The text below replaces paragraph 4.5.48:

The text below replaces paragraph 4.5.49:

Figure 4.37A Kennington Park - Potential Hard Landscape Materials

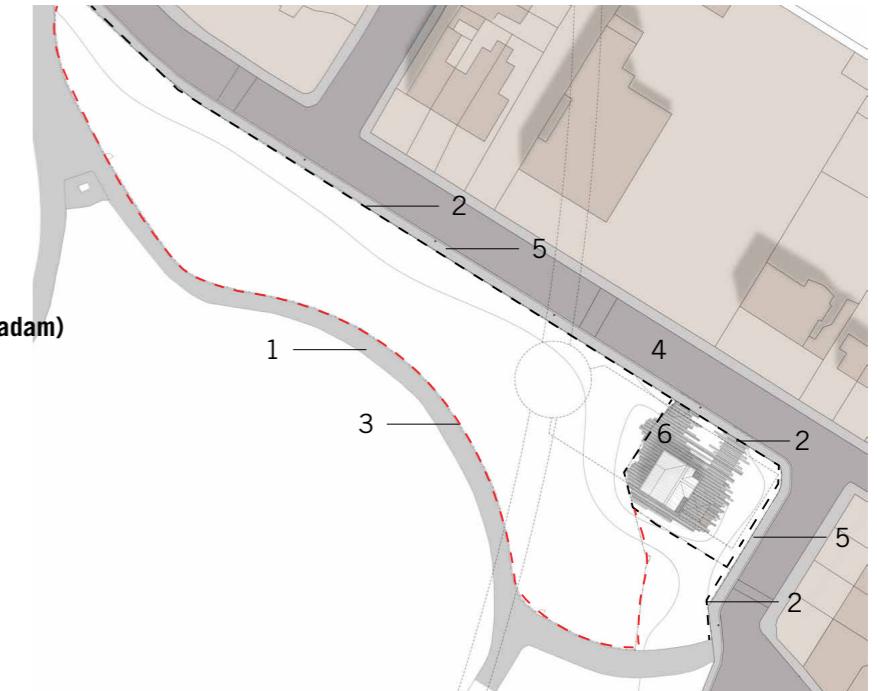
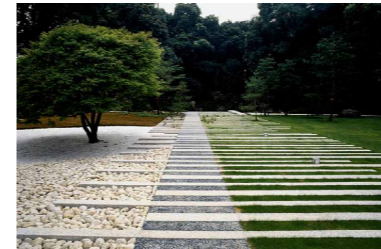
Figure 4.37 Kennington Park – Potential Hard Landscape Materials has been replaced with Figure 4.37A Kennington Park – Potential Hard Landscape Materials.

1. Existing park footway to be reinstated (Tarmacadam)

2. Existing park railings to be reinstated with new panels

3. Fence to dog walking area (Vertical steel bar fence)

4. Existing road surface to be reinstated

5. Existing footway to be reinstated (Tarmacadam)

6. Concrete pavers
